1 Calibration

1.1 Ongoing Performance Monitoring

Figure 1: *Figure 1: Tests with two LEDs on the board 1: signals measured at odd connectors 1 and 19 on the left side.*

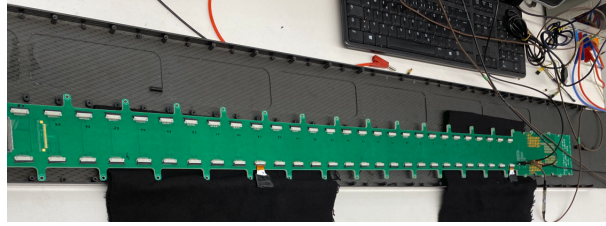
what is the benefit of this?
